To: Board of Appeals
From: Brookline Planning Board
Date: March 9, 2017
Subject: **Construct an enclosed front entry**

Location: **87 Craftsland Road**
Atlas Sheet: 121
Block: 423
Lot: 06-01

Case #: 2017-0007
Zoning: S-7
Lot Area (s.f.): 6,500

Existing front elevation of 87 Craftsland Road and location of new entryway

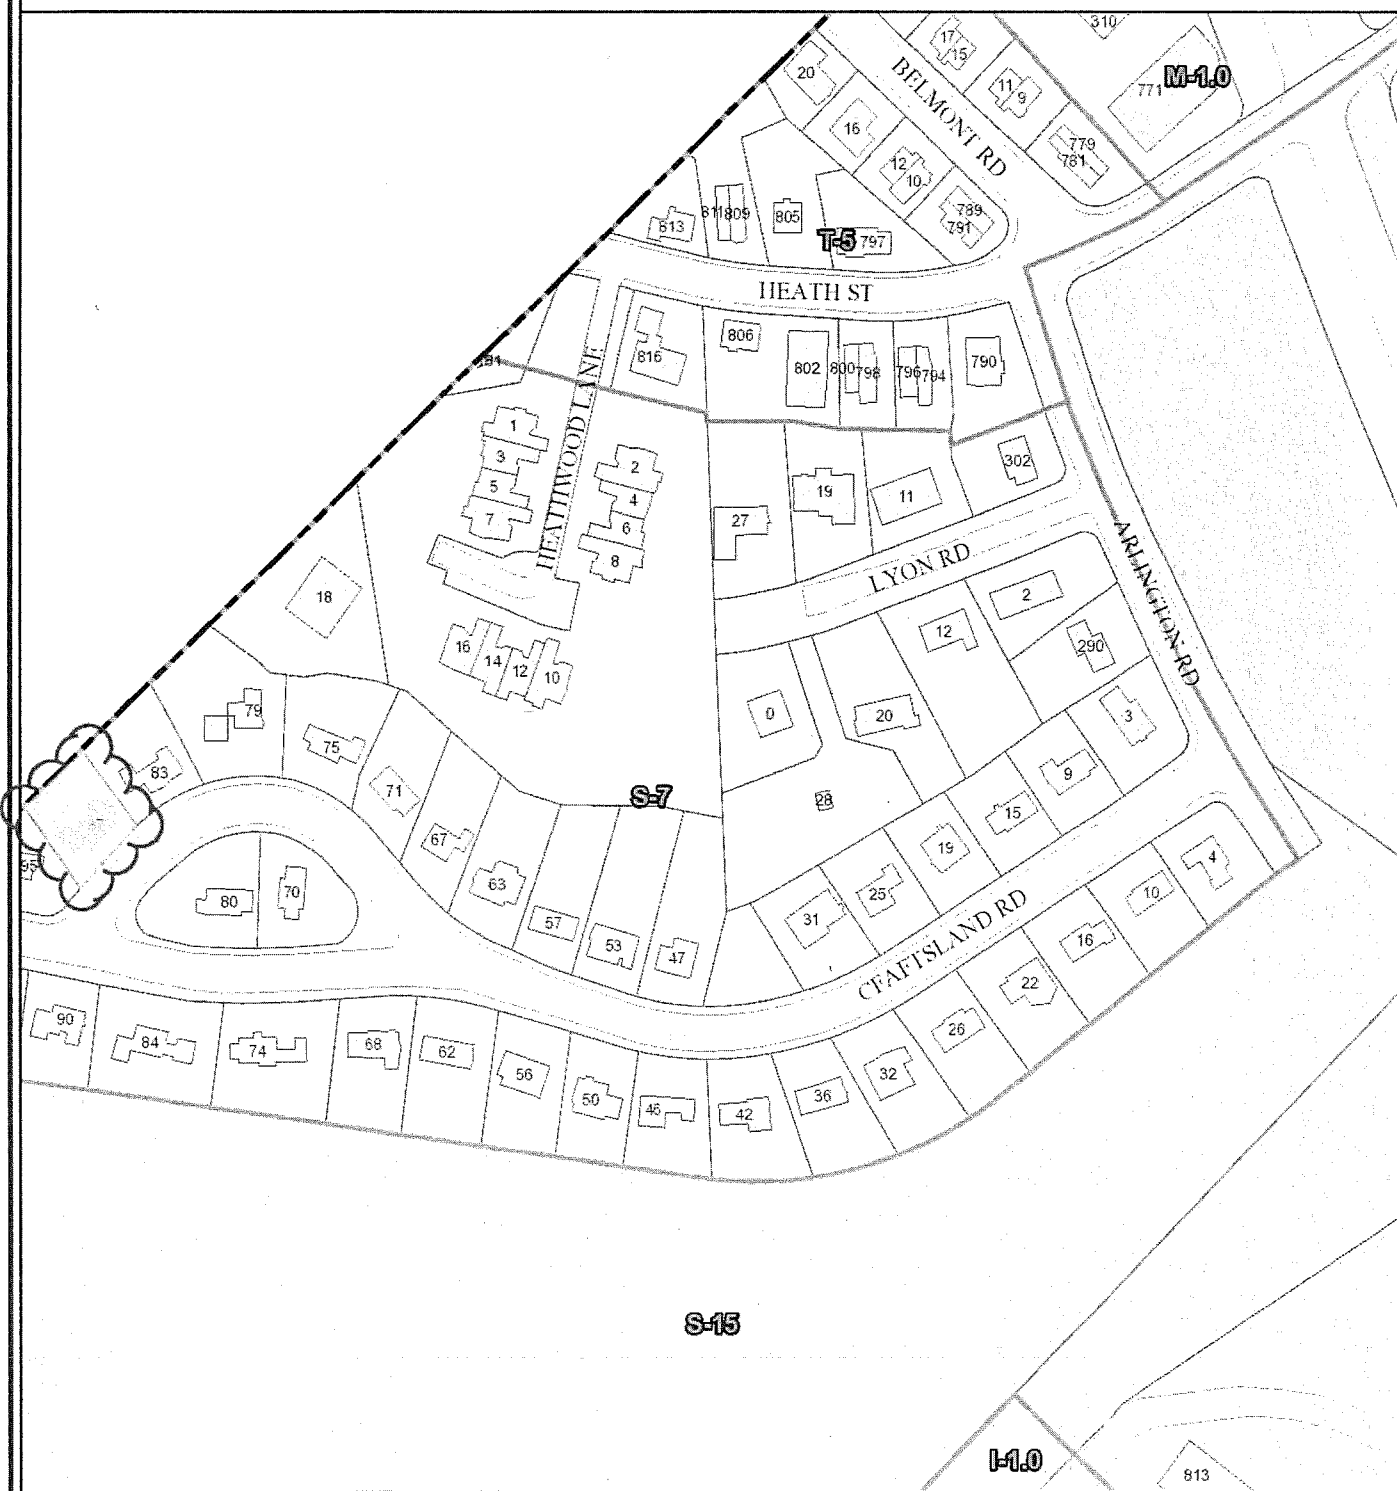
The Planning Board is supportive of the proposal to construct an enclosed entry way at 87 Craftsland Road. It is attractively designed, and the relief sought is minimal. The applicants are proposing new plantings on either side of the entryway as a counterbalancing amenity.

Therefore, the Planning Board recommends approval of the site plan plans, by Joseph R. Porter, dated 12/8/2016, and floor plans indicating a 6'x10' new vestibule addition submitted by Kip Schultz titled "87 Craftsland Road" subject to the following conditions:
